Subject: Proposed SECY on ROP Enhancement

Project Number: 689

Attachment NEI Comments on ROP Enhancement

In oral remarks, the staff expressed concern about a rising trend in the length of time taken to close a white performance indicator. The trend is depicted in the graph below, taken from slide 14 in the staff’s April 24 presentation package.

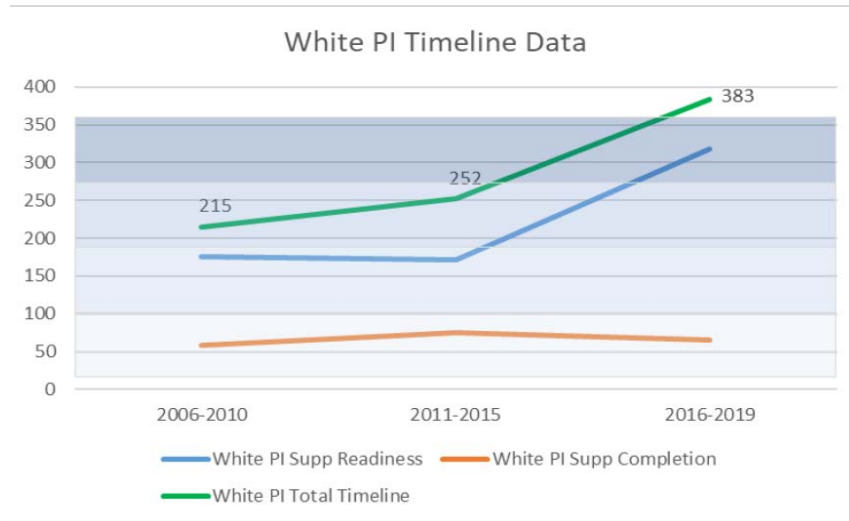
The graph shows a dramatic rise (52 percent) to 383 days to close a white performance indicator in the 2016–2019 interval. In our examination of the staff’s data, we note there has been an even more dramatic reduction (i.e., improvement) in the number of white performance indicators over the period of time shown in the NRC graph. In the interval 2006–2010, we counted 33 occurrences of a white PI in the staff’s dataset; 23 occurrences in the 2011–2015 interval, and only five occurrences in the 2016–2019 interval. The decline in the number of white PIs per interval should be recognized as a substantial improvement in licensee performance since the beginning of the ROP. In the face of this fleet-wide improvement, the staff asserts that a rise in the average number of days to close a white PI in a dataset of just five occurrences is a sufficient basis for the NRC to conclude there is a problem.¹⁴ In our view, the apparent rising average is, at most, a sign that further study is needed (as we explain below, we see extenuating circumstances in the most recent instances). Thus, we do not see in the sparse data proof that a major change is needed in how white PIs are treated in the ROP.

The staff has also asserted that it should not take longer to close a white PI than to close a white finding. Yet, we know that performance indicators and inspection findings are fundamentally different inputs to the ROP, and the licensee and NRC response to both differs in important ways that are not captured in the staff’s metric of average days to closure.
